Old Conway Design
Overlay District

DESIGN REVIEW BOARD MEETING

LONGING PROPERTY -- 517 & 521 3RD STREET OLD CONWAY DESIGN REVIEW

Longing Single Family Homes Review

SCALE 1" = 50'

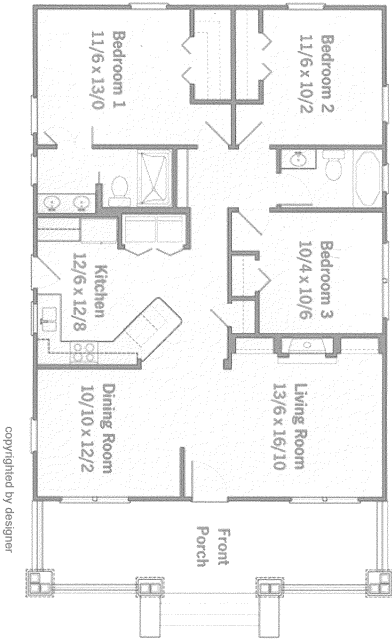
Setbacks: The proposed structures should respect the predominant setbacks of area homes, especially the front setback. The average area front setback is approximately 35 feet from the back of the curb. The proposed 42 feet from curb location should be slightly decreased as front setbacks are to be between 85% and 115% of the area average. In this case, 30 to 40 feet. Basically, the new homes should line up with existing homes on either side.

Tree preservation: The OCDOD ordinance requires that any significant trees over 8 inches in diameter be preserved. There are five significant willow oaks (pin oaks) on the property. Four of these trees are on the east property line. The fifth oak appears to be right on the dividing property line of the two new lots. With proper construction techniques, the trees should be unaffected. Old Conway Design Overlay regulations also require one street tree per 30 feet of street frontage. One street tree per lot should be planted.

1. Homes should be constructed as submitted including all door and window openings.
2. The front setback at the porch line shall line up with adjacent homes.
3. Driveways shall not exceed 20 feet in width.
4. A 4 foot wide sidewalk shall be constructed across both new lots. A sidewalk shall also be constructed across the parent lot to the east per subdivision regulations.
5. Existing large willow oaks shall be preserved. Fencing and proper tree protection beneath the drip line shall be utilized during construction. One canopy street tree (mature tree height of 40-60 feet) per new lot shall be planted.
6. Rough floor to Ceiling height shall be minimum of 9 feet.
7. Foundation shall be minimum of two blocks (18") high.
8. Porch depth shall be a minimum of 6 feet.
